**FINAL DRAINAGE REPORT
FOR
PLATTE SELF STORAGE
COLORADO SPRINGS, COLORADO**

MAY 2024

Please include project No.
PPR2418

Figure 8-12. Inlet Capacity Chart Sump Conditions, Curb Opening (D-10-R) Inlet

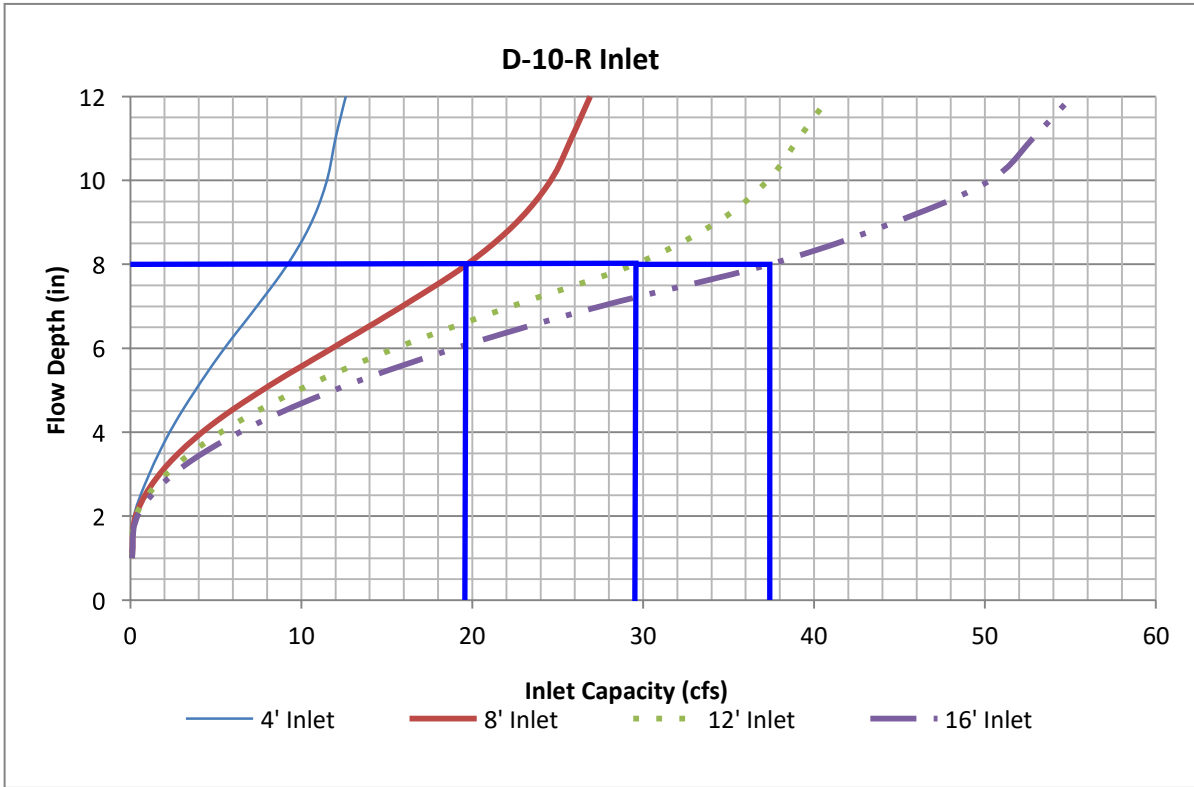
Please include inlet
management tab, and
inlet calculations.

Also include calculations for
riprap outlet protection

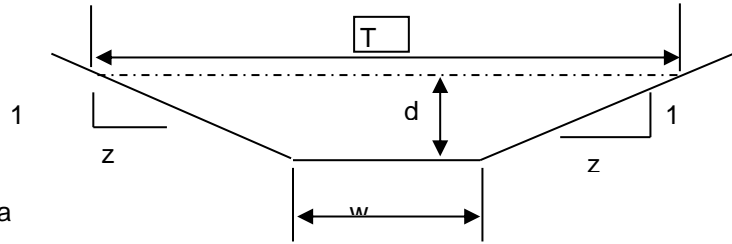
Please provide erosion protection for this open channel as velocity is above the standard velocity per DCM vol.1, chapter 10, table 10-4

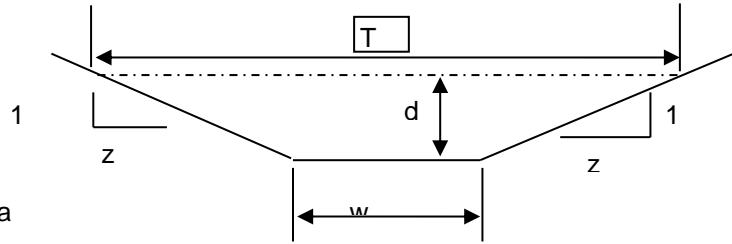
Please provide erosion protection for this open channel as velocity is above the standard velocity per DCM vol.1, chapter 10, table 10-4

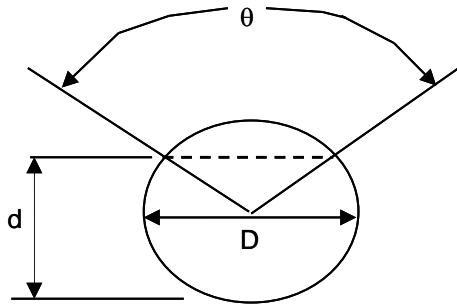
Please provide erosion protection for this open channel as velocity is above the standard velocity per DCM vol.1, chapter 10, table 10-4

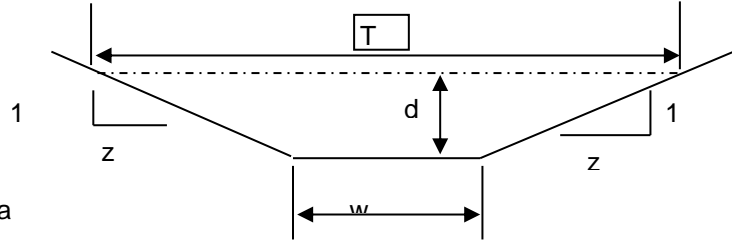
Please provide erosion protection for this open channel as velocity is above the standard velocity per DCM vol.1, chapter 10, table 10-4

Per DCMv2 – Chap 4.2, trickle channel should at a minimum provide capacity equal to twice the release capacity at the upstream forebay outlet. Provide these calcs in the drainage report and revise plans as needed.

PLATTE SELF STORAGE
EXISTING DRAINAGE MAP

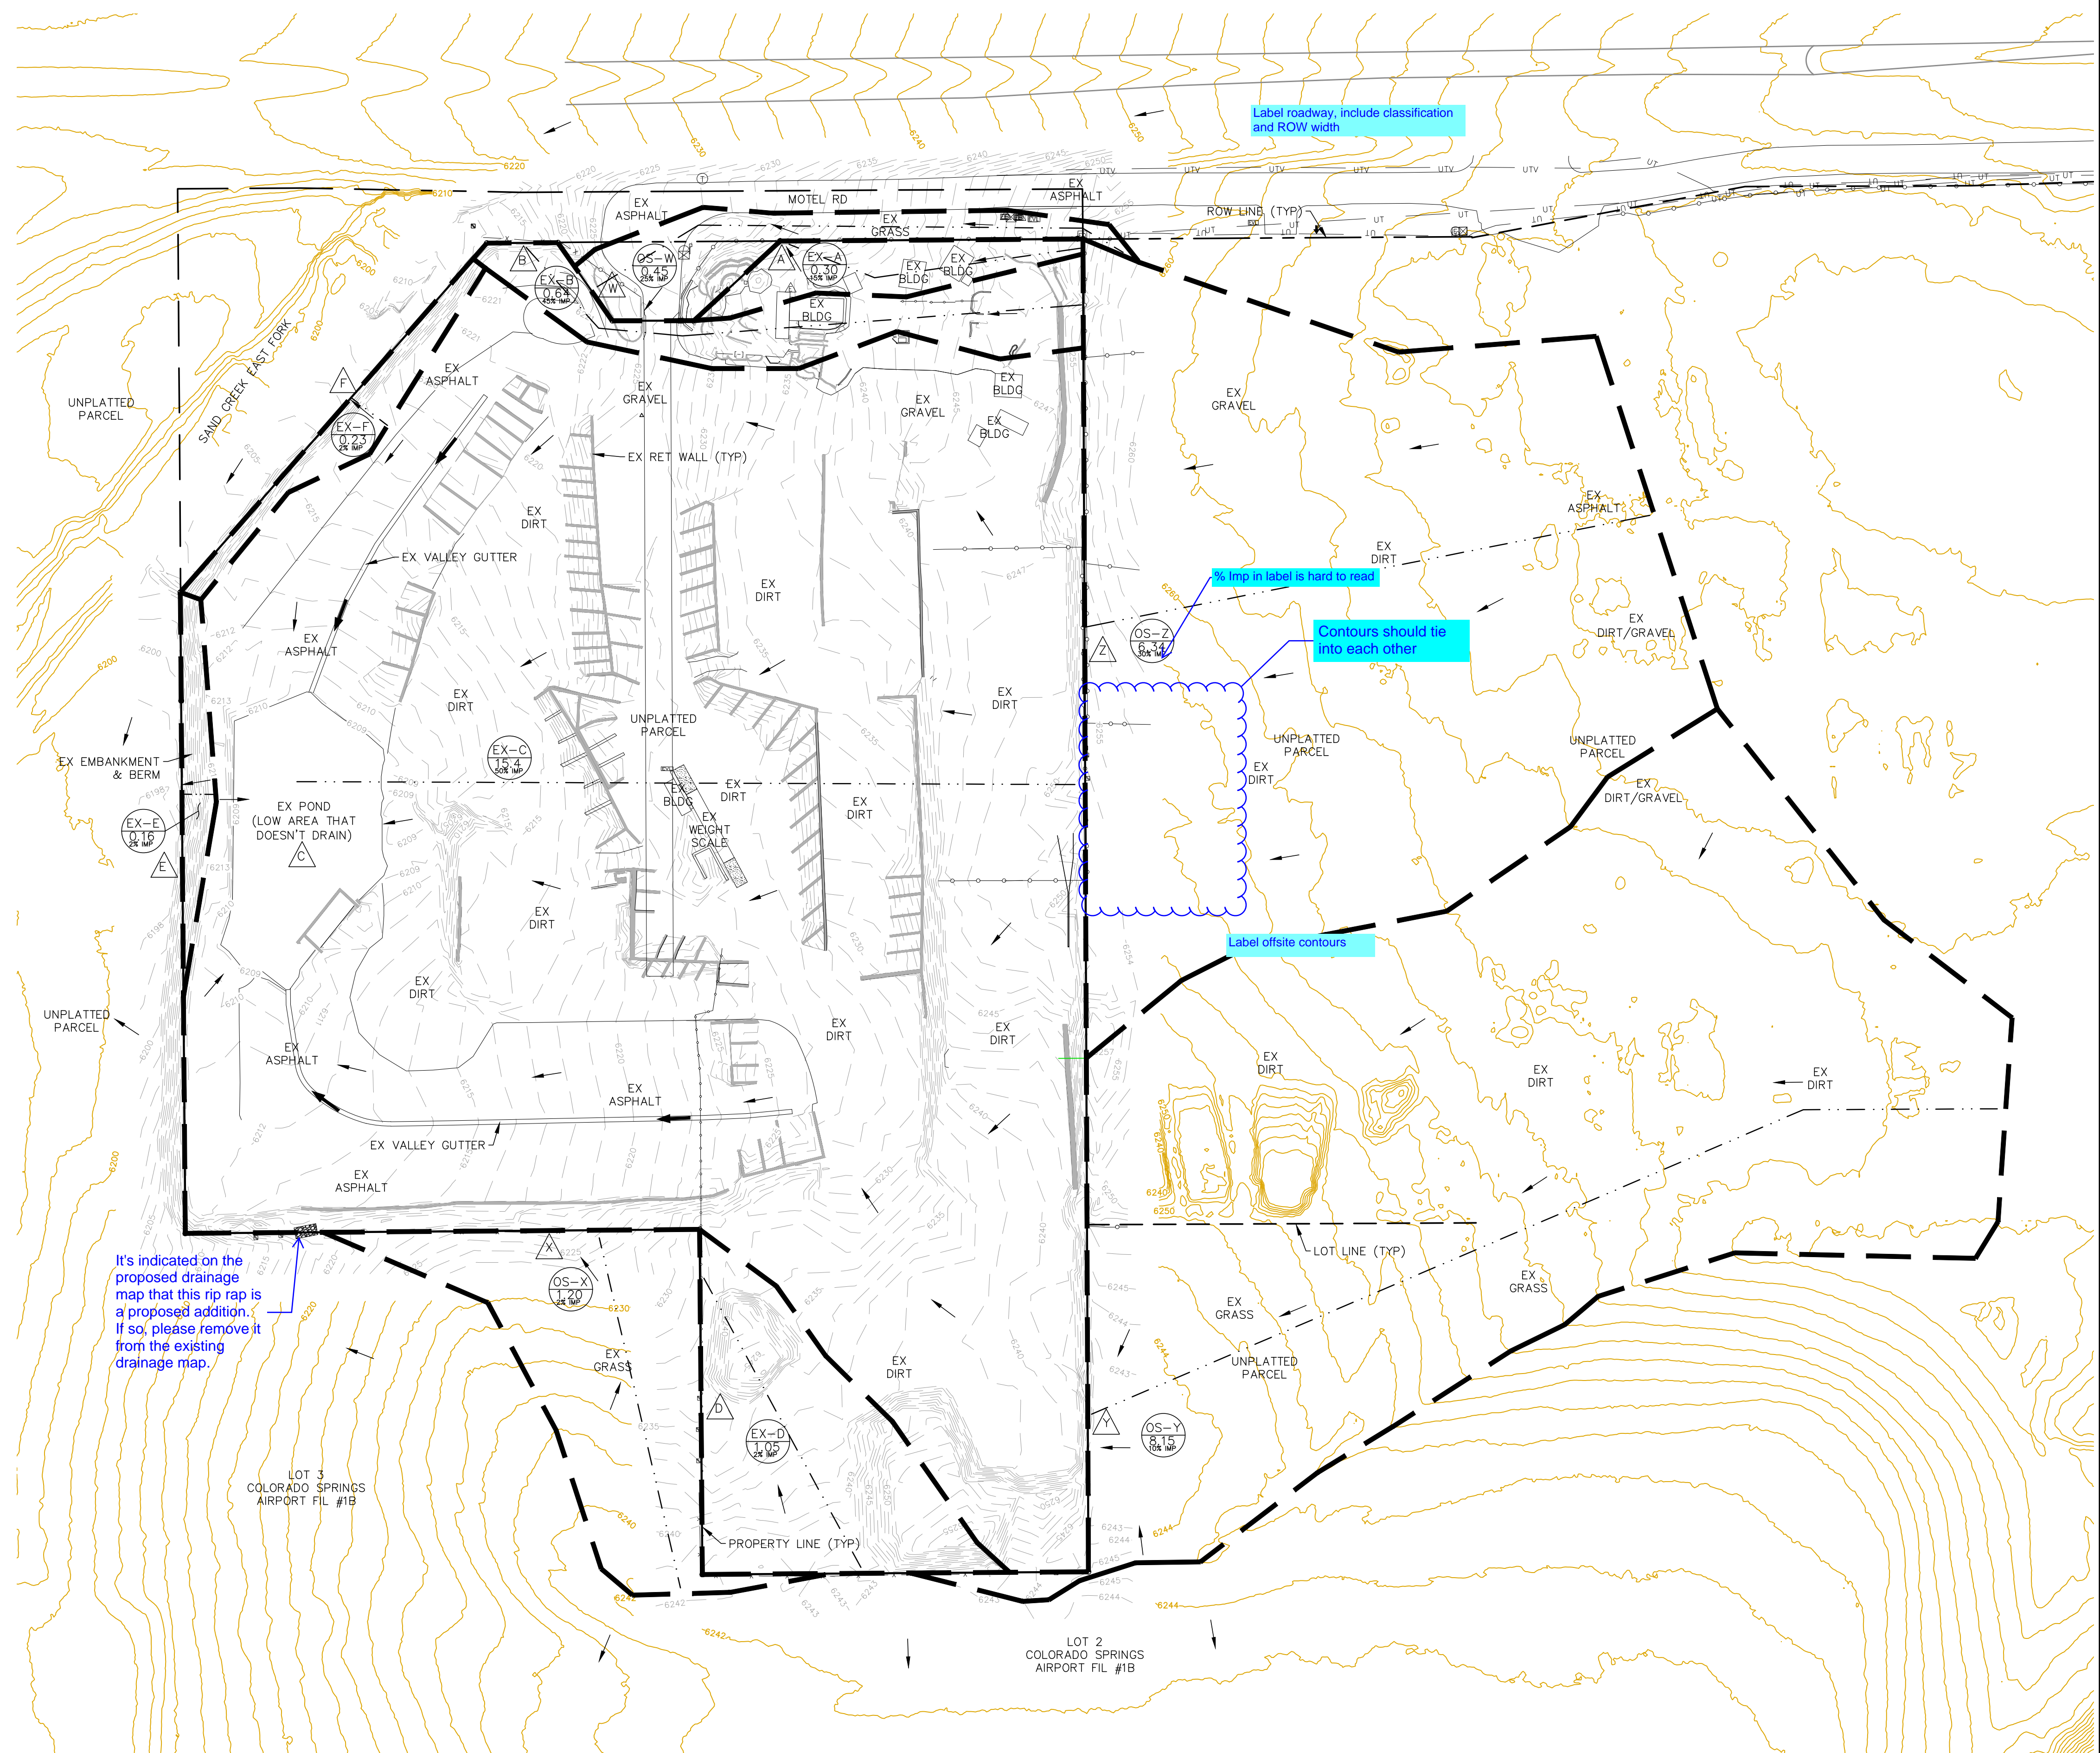
It's indicated on the proposed drainage map that this rip rap is a proposed addition. If so, please remove it from the existing drainage map.

PLATTE SELF STORAGE SITE DEVELOPMENT PLAN PROPOSED DRAINAGE MAP MAY 2024

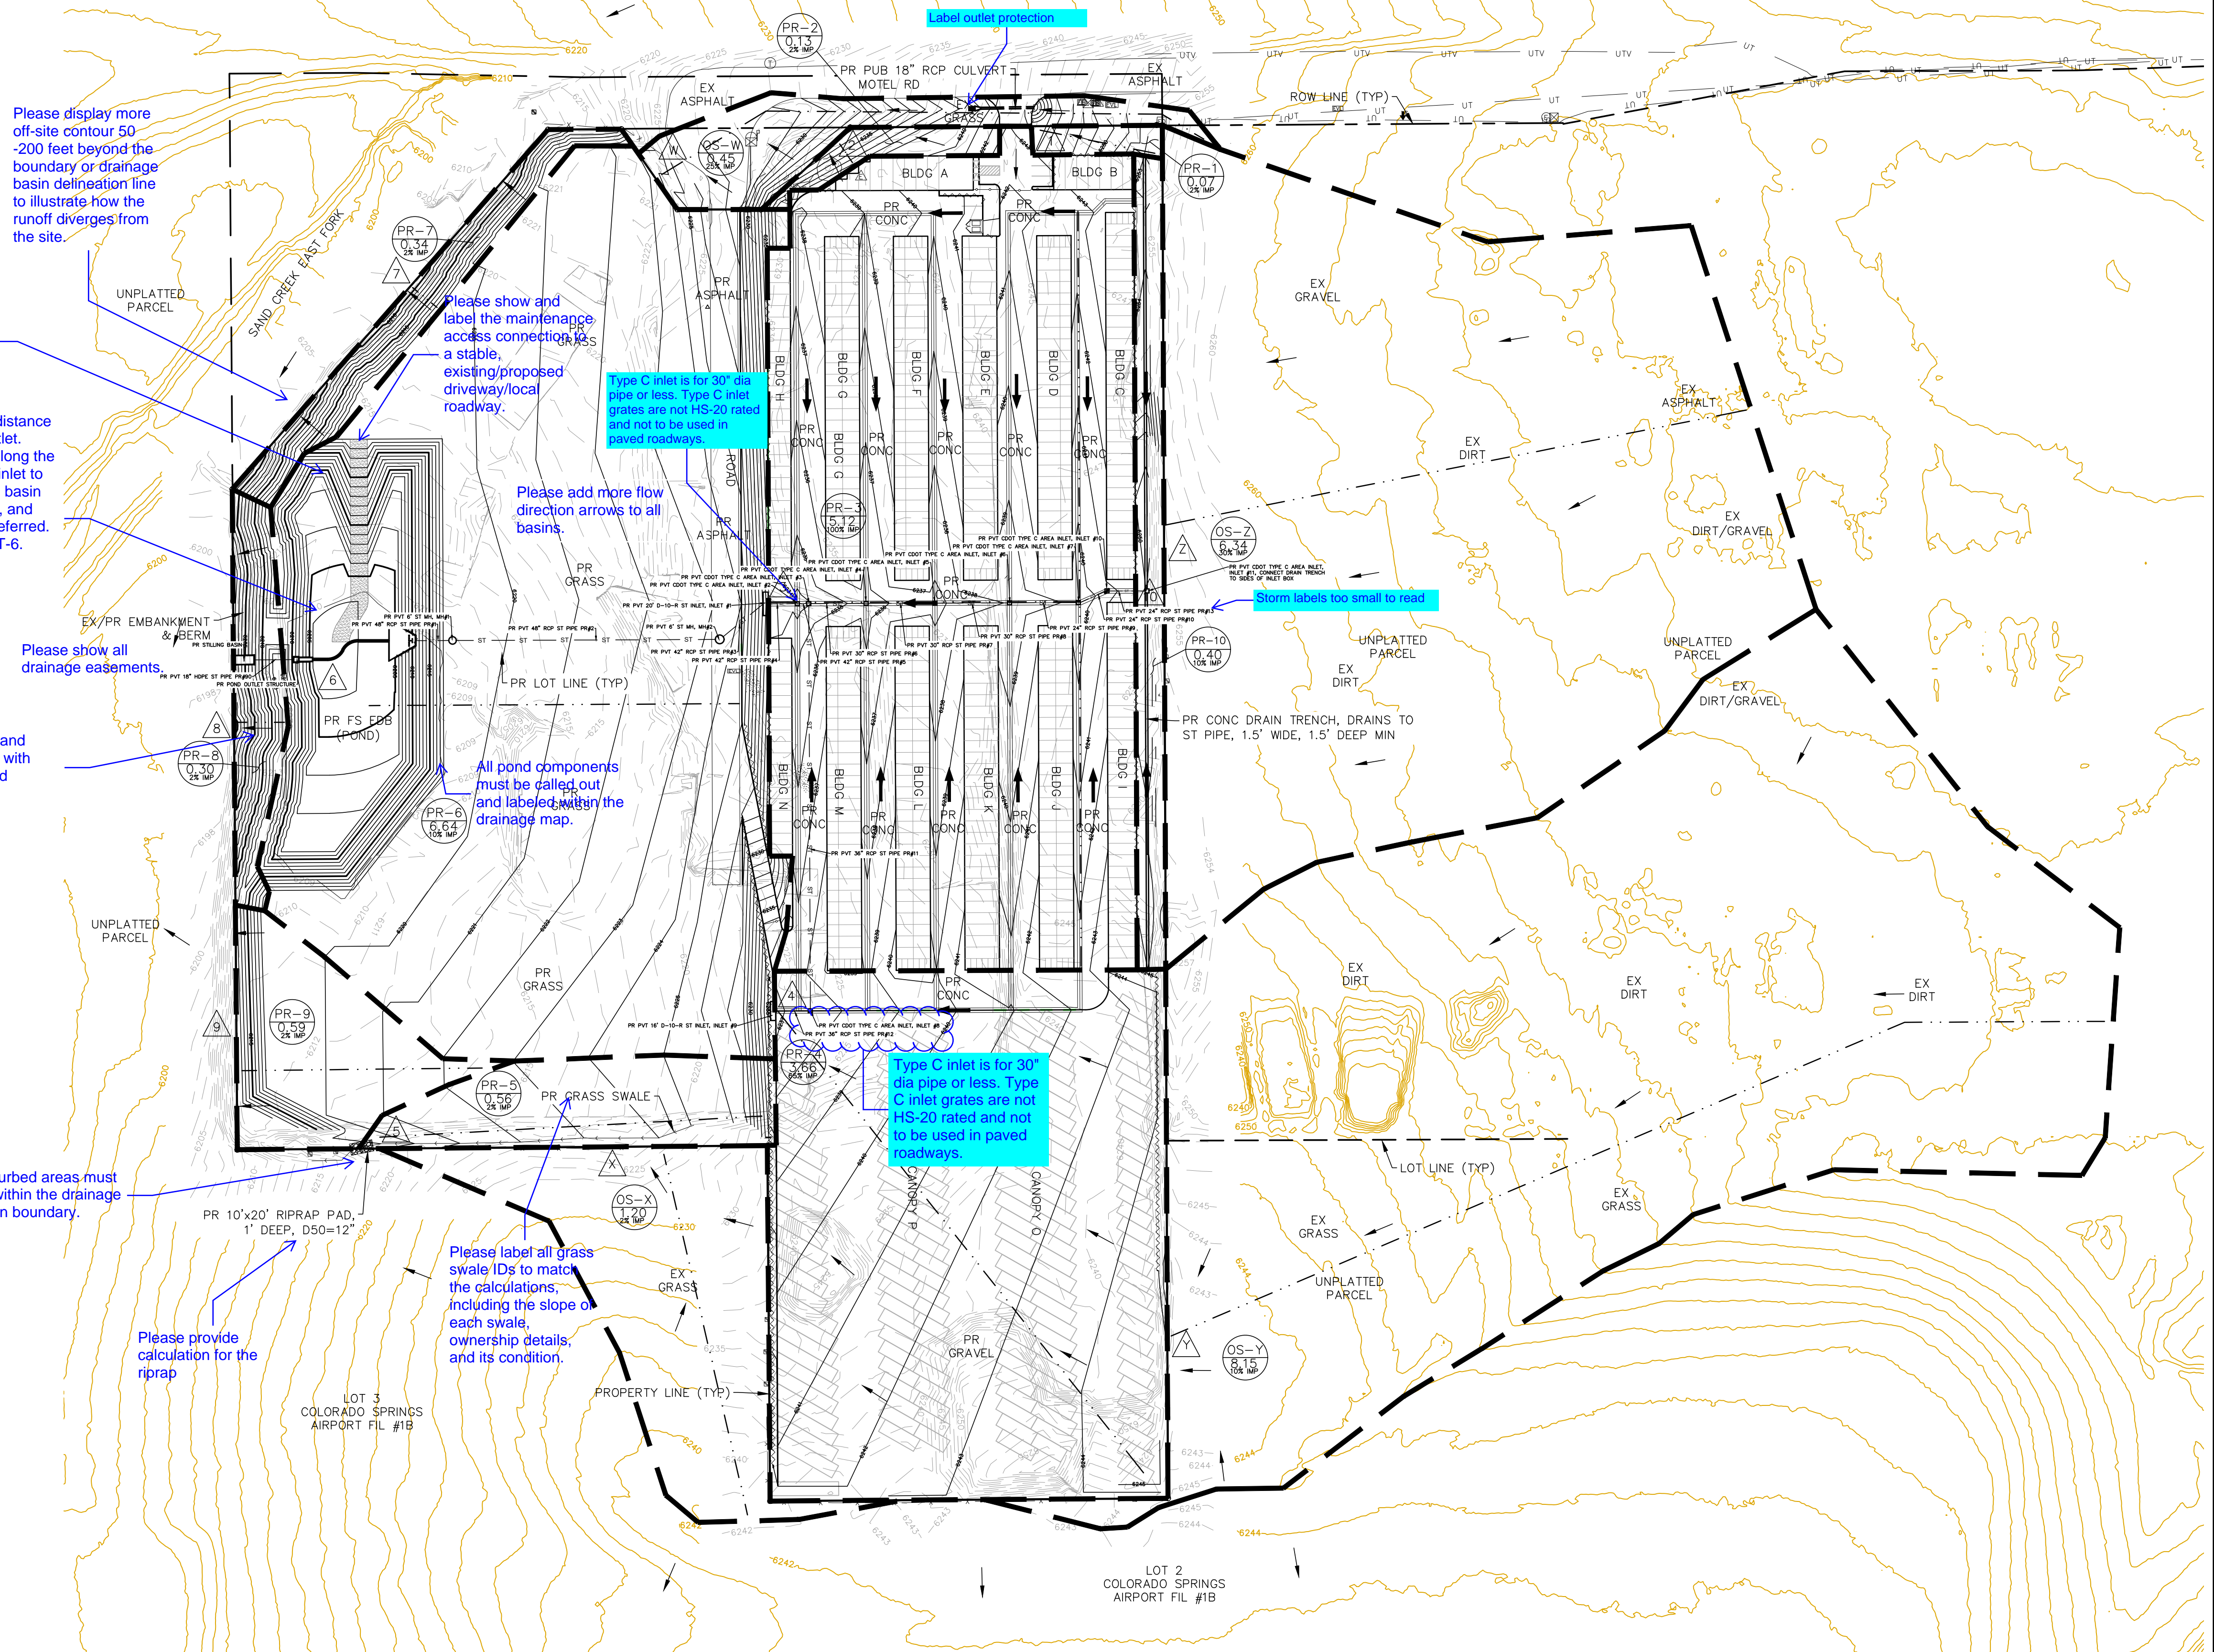
Please show and label all side slope of the pond. Side slope cannot be steeper than 3:1.

Please consider the distance between inlet and outlet. Distance measured along the trickle channel (from inlet to outlet) to the average basin width is at least 1.5:1, and greater than 2:1 is preferred. USDCM, Chapter 4, T-6.

Please show all drainage easements.

Please show and label spillway with type, size, and condition.

Please provide calculation for the riprap
